April 1, 2021

ADDENDUM NUMBER ONE
TO
**SPRING MILL STATE PARK
WALKWAY to DONALDSON CAVE
PROJECT NO: ENG1903740475**

SHEET TITLE: DETAILS (1 OF 2)

WALKWAY SECTION NTS

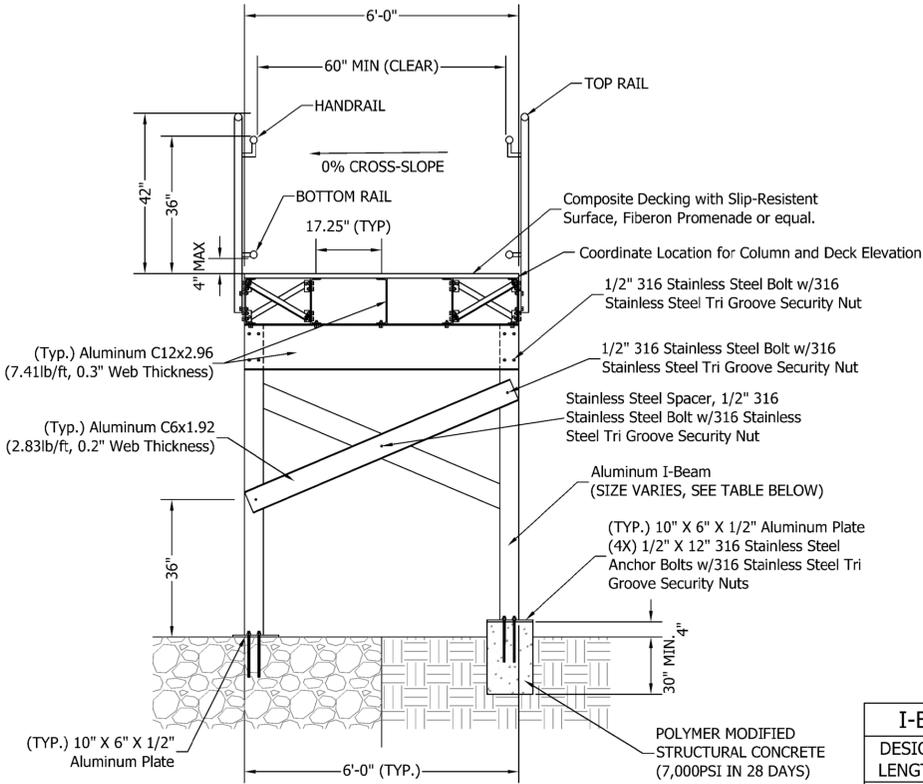
Sheet 14 of the drawing set is revised and attached.

- A. Continuous handrails are required
- B. Decking shall be perpendicular to the pathway
- C. All welded connections shall be field painted.

1. SOLID COMPOSITE DECKING WITH SLIP RESISTANT COATING, FIBERON PROMENADE OR EQUAL
2. 10' MAX LENGTH TO ANY PIECE DELIVERED TO SITE BY UTV.
3. CONTRACTOR TO CORE AND SET ALL FOOTERS AND PREP SURFACE OF ROCK FOR 1/2" ALUMINUM BASE PLATE, PLACE I BEAM VERTICAL SUPPORTS AND CUT TO LENGTH TO MEET PLATFORM GRADE. I BEAMS TO BE WELDED TO 1/2" ALUMINUM BASE PLATE.
4. ALL COMPONENTS PREFABRICATED AND ASSEMBLED AND FASTENED ON SITE.
5. MATERIALS - ALUMINUM WITH STAINLESS STEEL HARDWARE
6. ALL DECKING TO BE INSTALLED PERPENDICULAR TO TRAVEL
7. FIELD PAINT ALL WELDED CONNECTIONS.
